National Institute for Occupational
Safety and Health
Robert A. Taft Laboratories
4676 Columbia Parkway
Cincinnati, OH 45226-1998
Phone: 513-533-6825
Fax: 513-533-6826

August 22, 2006

Attachment 1
Responses to Issues Raised in Mr. Edwin Walker's June 25, 2006 E-mail

FIGURE 1. Fabrication Temperatures for Uranium

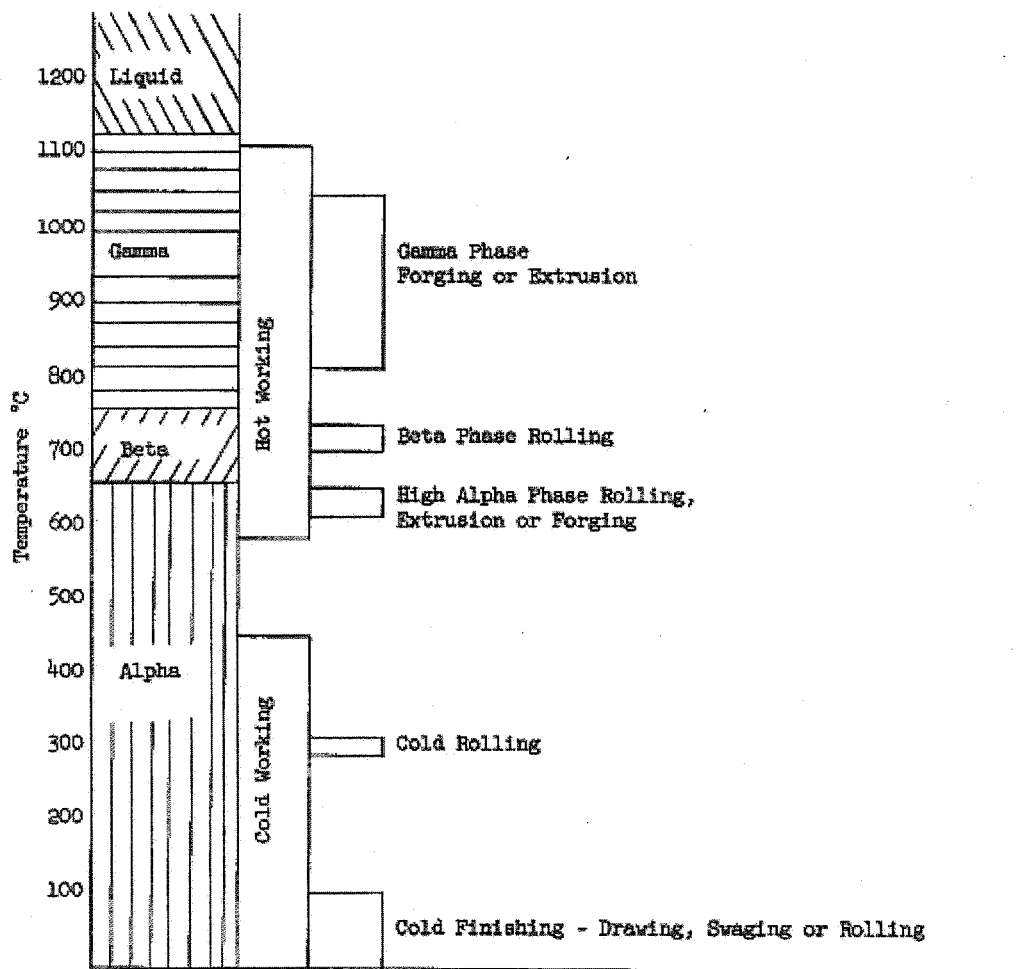
GAMMA RAYS - NIOSH states no Gamma rollings took place at Bethlehem Steel. Refer to document HW -22474 Finished Rollings Done at Bethlehem Steel -“ 4 to6 12 foot long gamma extruded rods”.

If no gamma rollings were done, then why does the “Elimination Analysis” refer to “The survey included direct measurement of alpha and beta-gamma radiation levels”? January 25, 2005 Findings - Item #8 (Beta and Gamma).

I would like to clarify that the terms alpha, beta, and gamma phases are all related to the structure of the metal (not the radioactivity content) following rolling at various temperatures (please see the figure below). The gamma extruded rods were rods extruded at temperatures higher than the temperature used when rods were rolled. The gamma in this case refers to the lattice structure of the metal grain; it does not refer to radioactivity. The gamma referred to in (9.a.) above is gamma radiation which can also be referred to as photon radiation. Dose from photon (gamma and x-rays) radiation estimates have been included in all revisions of the BSC TBD for all years. The following figure from HW-34868, Nuclear Metallurgy Lectures from 1955 shows the various physical structures based on

rolling temperatures. These terms have no relationship with radioactivity in this context.
